To: Columbia River Crossing Taskforce

From: Pier 99/North Waterfront Properties

RE: Draft Environmental Impact Statement dated 5-2-08

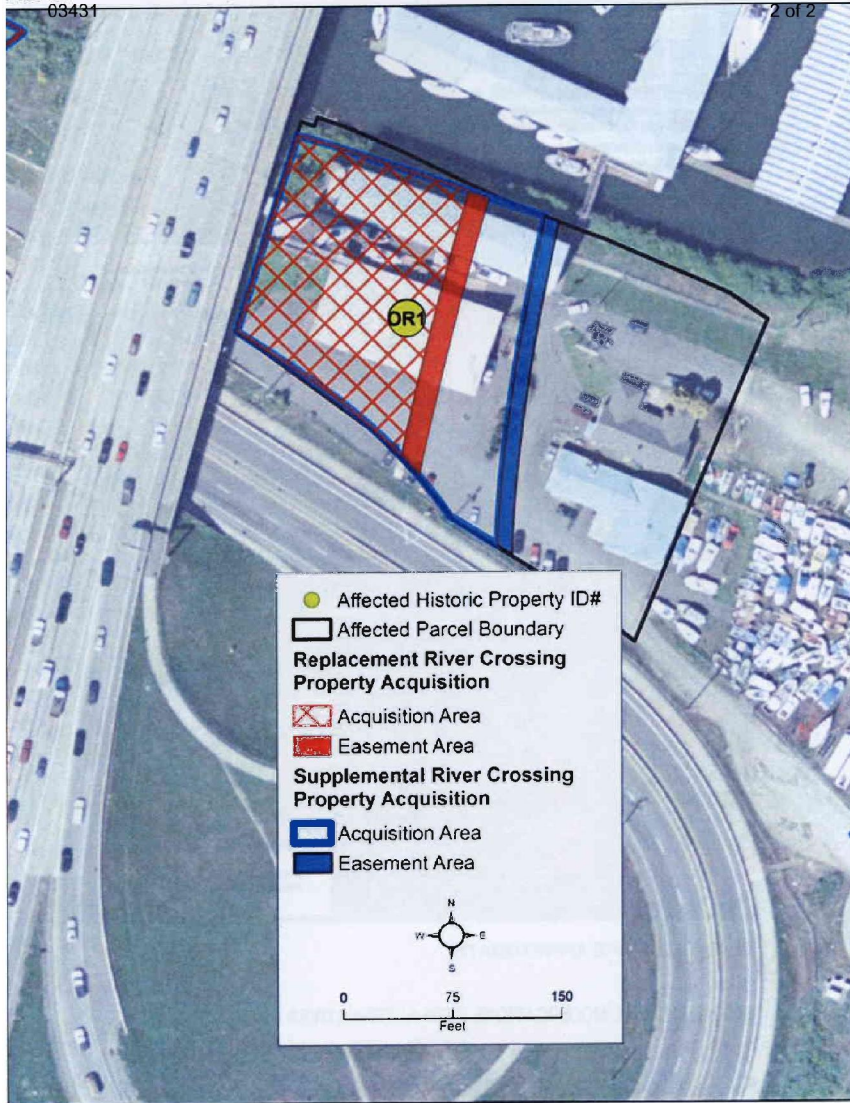
B-043-001 The attached diagram portrays the Pier 99 property and shows impacts to the property. One option shows acquisition of a portion of the property which bisects the showroom, the other option appears to show acquisition of a larger portion of the property. No reference is made to the impact of the existing moorage.

B-043-002 1. The diagram shows acquisition areas and easement areas what is the difference?

B-043-003 2. The diagram outlines the entire impacted parcel. It is important to know the impact to the existing businesses and uses to the entire site and how will any partial taking affect the remaining land.

Current designs would result in the displacement of the Pier 99 showroom and associated marina. The single family home and additional storage on the site would not be impacted.

The portion of the property shown as an acquisition would be acquired in fee (i.e., all rights to the property would be obtained), whereas the easement areas indicate those portions of the parcel where only one or more, but not all rights, to the property would be acquired. In the case of this exhibit, the right to access the easement areas, but not full property ownership, would be obtained in order to maintain the bridge structure.

See response to comment -001.
